**TO: El Paso County Board of County Commissioners**  
**Stan VanderWerf, Chair**

**FROM: Nina Ruiz, Planning Manager**  
**Jeff Rice, PE Engineer III**  
**Craig Dossey, Executive Director**

**RE: Project File #: SP-19-006**  
**Project Name: Saddlehorn Ranch**  
**Parcel Nos.: 43000-00-599, 43000-00-600, 43000-00-601, 43000-00-602**

# Exhibit B

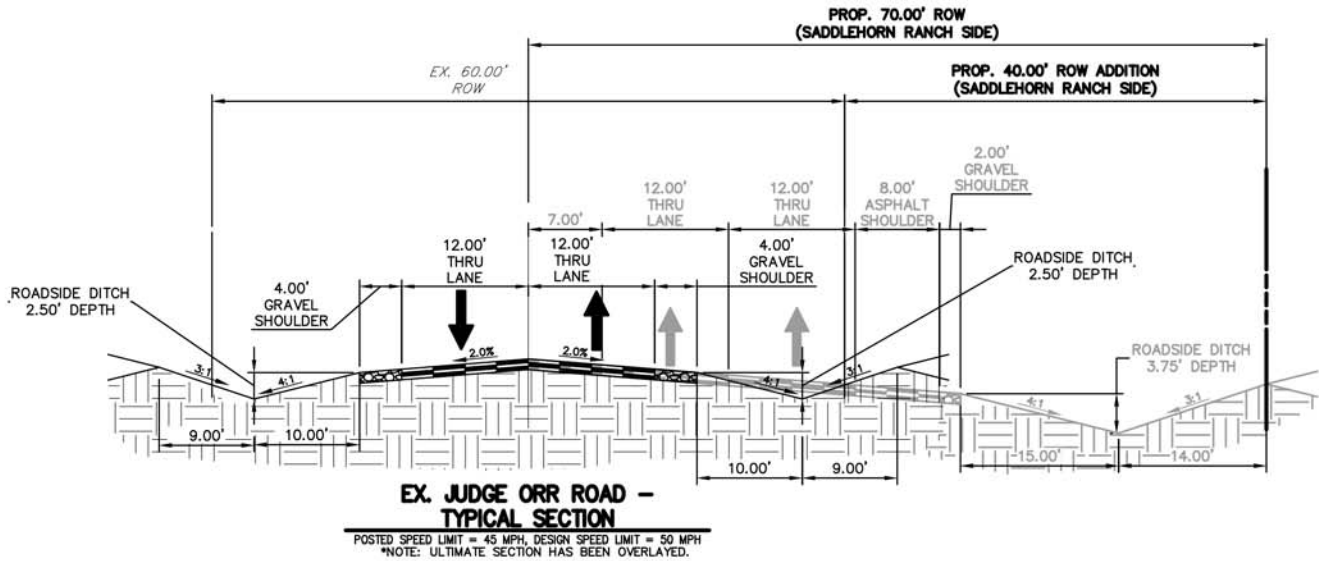
- 2.) Re. Judge Orr Road: Deviation request from the standards of or in section ECM Section 2.2.4 Roadway Functional Classifications of the Engineering Criteria Manual (ECM) is requested. The 824 acre Curtis Road Development Traffic Impact Analysis Indicates Judge Orr Road is classified as a "4 Lane Minor Arterial" in the El Paso County 2040 Major Transportation Corridors Plan. The ECM currently has no standard cross section for a 4 lane minor arterial. It is assumed that a 4 lane minor arterial (rural) cross section would add a 12 ft. travel lane in each direction to Figure 2-5 Typical Rural Minor Arterial Cross Section (two lane). See Exhibit A. The purpose of this deviation is to document the cross-section and ROW dedication necessary to be shown on the preliminary plan. To explain the proposed alternative, and compare to the ECM standards, see Exhibit A for available ECM cross sections and see Exhibit B for the existing Judge Orr Road cross section. The applicant will provide a 90 foot half right of way on all plats adjacent to Judge Orr Road consistent with the anticipated ROW needs identified in the MTCP. The applicant is also subject to the El Paso County Road Impact Fee per resolution No. 19-471 and is therefore paying its fair and equitable share of necessary improvements identified in the MTCP. Re. Limits of Consideration, the category of "a change to a standard is required to address a specific design or construction problem, and if not modified, the standard will impose an undue hardship on the applicant with little or no material benefit to the public" has been selected. Regarding justification, the MTCP minor 4-lane arterial cross-section is not provided in the Engineering Criteria Manual. Under Criteria for Approval, the first criterion considers whether the deviation will achieve the intended result with a comparable or superior design and quality of improvement. In response, this request is not based on financial considerations. There is not enough ROW to accommodate a 4-lane minor arterial street section. Per Table 10 of the Traffic Impact Study, Judge Orr is MTCP Project No. C15 and applicant will pay into the Fee program traffic impact fees to participate in funding the project. See Exhibit C. The second criterion considers whether the deviation will adversely affect safety or operations. The response is the deviation will not adversely affect safety or operations as Judge Orr Road is an existing, operable roadway. As final plats take access to Judge

Orr Road each intersection will be designed to accommodate the requirements listed in Table 10 Roadway Improvements of the Traffic Impact Study. The third criterion asks that the deviation will not adversely affect maintenance and its associated cost. The response is that the maintenance of the roadways will not be impacted as the existing roadway will be left in its existing condition at this time. The fourth criterion asks that the deviation will not adversely affect aesthetic appearance. In this instance, the deviation has no bearing on the aesthetic appearance. The fifth criterion asks that the deviation meets the design intent and purpose of the ECM standards. The response contends the deviation meets the design intent and purpose of the ECM standards. Once ROW can be obtained, the road can be built out to the full 4-lane minor arterial street section. The sixth criterion asks that the deviation meets the control measure requirements of Part I.E.3 and Part I.E.4 of the County's MS4 permit, as applicable. The response is the deviation meets the control measure requirements of Part I.E.3 and Part I.E.4 of the County's MS4 permit, this project is proposing Water Quality facilities as required by the criteria.

### Exhibit E

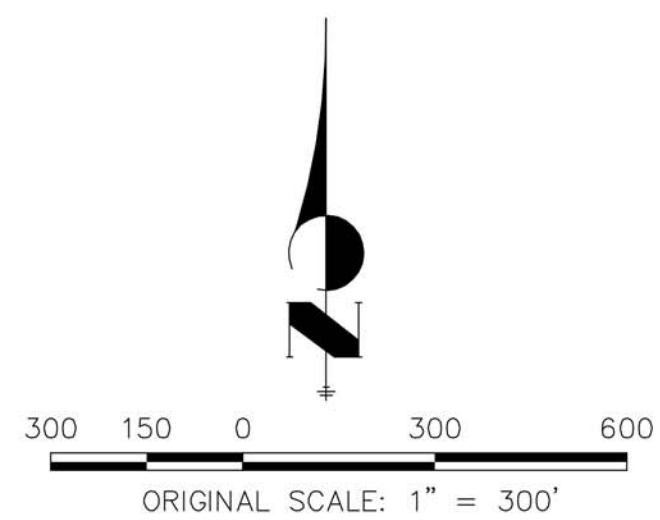
- 3.) Re. Cul-de-sac length: Deviation request from the standards of or in Section ECM Section 2.3.8 Roadway Terminations for cul-de-sac horizontal design of the Engineering Criteria Manual (ECM) is requested. ECM criteria for maximum cul-de-sac length of 1,600 feet for rural condition. The proposed design also requires a waiver of the El Paso County Land Development Code 8.4.4D for the maximum number of lots on a cul-de-sac until the time that the connect through to future subdivisions to the east and south. The reason for the requested deviation for maximum cul-de-sac length is due to planning for future development of the parcels to the east and south of the Saddlehorn development. The land plan assumes that in the future, when the parcel to east and south are developed; Barrosito Trail will become an interconnected street to the south and La Noria Way will become an interconnected street to the east. To create a loop would require the extension of a roadway west at Copperas Court that intersects with Benito Wells Trails and would require additional asphalt and a box culvert crossing the existing drainageway increasing stormwater runoff, maintenance and operations costs for El Paso County and the Saddlehorn Metro District. Until the land develops to the east and south, Barrosito Trail functions as a dead end cul-de-sac with a length of 4,392 feet from its intersection with Del Cambre Trail to its terminus at the southern property line of Saddlehorn Ranch. Temporary gravel cul-de-sacs have been added to the proposed end of Barrosito Trail and La Noria Way to allow for fire access and a public turnaround. These temporary cul-de-sacs will be gravel surfaced and meet ECM geometric criteria for rural cul-de-sacs shown on SD-2\_76. There is adequate area provided for placement of snow in the area between the edge of gravel and the edge of the Temporary Turnaround Easement. There will be no lots served by these temporary cul-de-sacs. See Exhibit E for a map graphically depicting the deviation request. A considered alternative land plan would be to extend a roadway west at Copperas Court that intersects with Benito Wells Trail. The alternative roadway would be 1,211 feet in length, serve no lots, and require a box culvert crossing an existing drainageway. This

plan review process and no objections or comments were noted. The Fire Department has reviewed the proposed layout of the deviation and has found it acceptable. A copy of the email from the Fire Department, Exhibit G, is attached. The sixth category in criteria for approval is that the deviation meets the control measure requirements of Part I.E.3 and Part I.E.4 of the County's MS4 permit, as applicable. In response, the deviation meets the control measure requirements of Part I.E.3 and Part I.E.4 of the County's MS4 permit, this project is proposing Water Quality facilities as required by the criteria. The use of additional roadway surfaces to complete a loop would result in increased land disturbance and stormwater runoff requiring water quality treatment and detention.

# Exhibit H

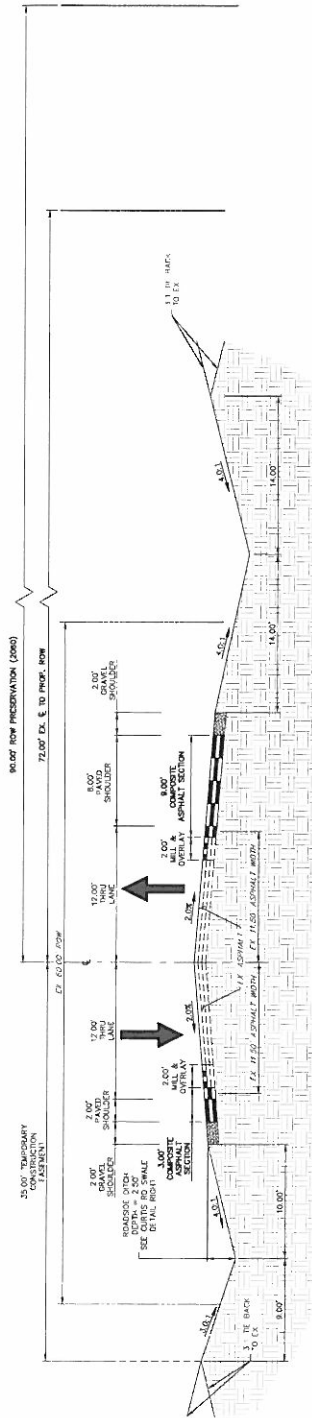
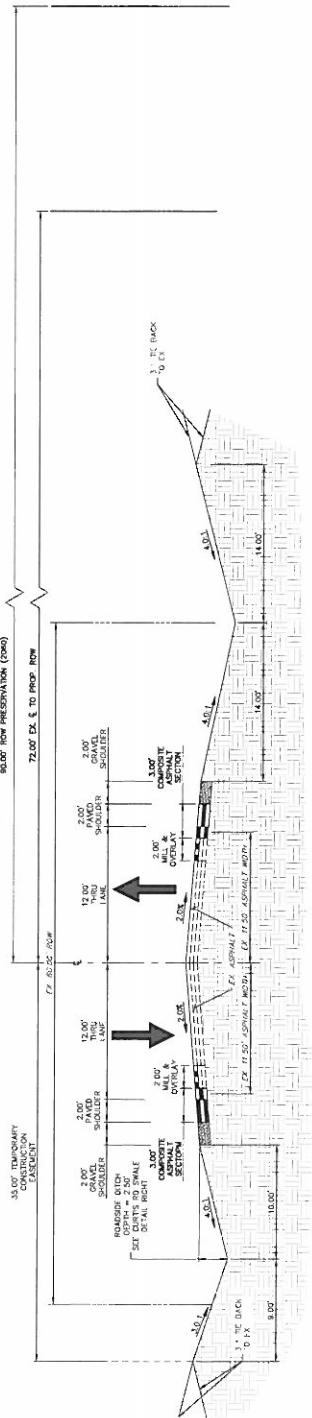
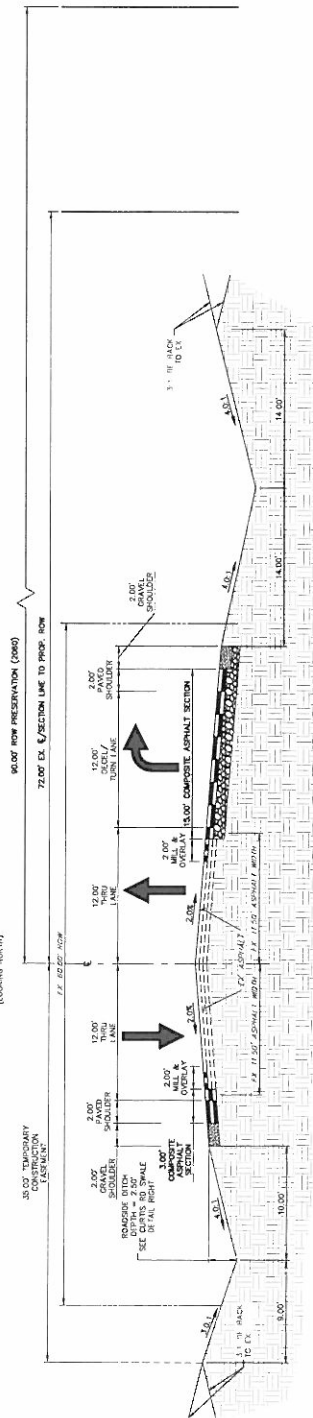
- 5.) Re. Curtis Road: Deviation request from the standards of or in section ECM Section 2.2.4 Figure 2-4 Figure Rural Minor Arterial of the Engineering Criteria Manual (ECM) is requested. ECM criteria for a rural minor arterial cross sections requires a 12' travel lane and an 8' paved shoulder. The 2040 MTCP identifies Curtis Road as a two-lane rural Principal Arterial. Since there is no standard 2-lane principal arterial cross-section, this deviation will document the proposed 2040 cross-section (rural minor arterial) and reasoning for the proposed ROW dedication width. The reason for the requested deviation is that in order to build the full cross-section, ROW would need to be obtained from adjacent property owners to accommodate the full 8' paved shoulder on the west side of the road. To place the burden of ROW acquisition from the adjacent property owners on the Saddlehorn development would not be fair or equitable. While the minor

arterial half-cross section could be built on the east (Saddlehorn) side of the road, it is not the appropriate time to build out the full-section until traffic warrants the arterial cross-section and both sides of the road can be constructed. As an explanation to the proposed alternative and comparing it to the ECM standards, the proposed alternative for the west side is for the 8' paved shoulder to be reduced to a 2' paved and 2' gravel shoulder. This is the maximum that can fit inside the existing western ROW. Exhibit H provides the proposed cross section. The applicant will provide a 72 foot half right of way along with an additional 18 foot ROW preservation on all plats adjacent to Curtis Road consistent with the anticipated ROW needs identified in the MTCP and the Preserved Corridor Network Plan. The applicant is also subject to the El Paso County Road Impact Fee per resolution No. 19-471 and is therefore paying its fair and equitable share of necessary improvements identified in the MTCP. For Curtis Road adjacent to Filing 1 east half-section, the applicant proposes to provide a 12 ft. travel lane, 2' asphalt shoulder and 2' gravel shoulder for Filing 1 development. The proposed alternative is consistent with the ECM Table 2.5 design criteria for a rural local roadway and intersections are projected to operate at a level of service C or better with the buildout of Filing 1. For Curtis Road adjacent to future filings, the applicant proposes to provide a 12' travel lane, 8' asphalt shoulder and 2' gravel shoulder on the east side. The proposed alternative is consistent with the ECM Table 2.4 design criteria for a minor arterial roadway. Per the rezoning approval, a condition was placed on Curtis Road requiring improvements to arterial road standards with potential reimbursement from the fee program. The condition wording is *"The adjacent portions of Curtis Road shall be improved to meet the minimum standards of an arterial roadway per the Engineering Criteria Manual. Improvements will be made as part of the Curtis Road access permitting. The necessary improvements and phasing will be clarified with the future applications for Preliminary Plan and Final Plat. The work may be subject to any reimbursement as outlined in the El Paso County Road Impact Fee Program"*. The applicant is providing adequate ROW to meet this condition for Filing 1 and is proposing a reduced cross section to local road criteria for Filing 1. Future filings adjacent to Curtis Road will dedicate adequate ROW and will build a rural minor arterial half cross section criteria once the County has obtained the additional ROW from western parcels. Exhibit H provides the proposed cross sections. A limit of consideration which is presented is that ROW must be obtained on the west side of the road for the full 8' paved shoulder to be constructed on Curtis Road. The maximum shoulder width that can be constructed inside the existing ROW is a 2' paved shoulder. This falls under the category of ROW limitation or impediments which may be addressed by an equivalent alternative. Regarding this, the justification is that ROW must be obtained on the west side of the road for the full 8' paved shoulder to be constructed on Curtis Road. The maximum shoulder width that can be constructed inside the existing ROW is a 2' paved shoulder. The deviation will achieve the intended result with a comparable or superior design and quality of improvement. This deviation will improve the roadway by adding a shoulder and maintain a consistent cross section until such time as the additional western ROW is
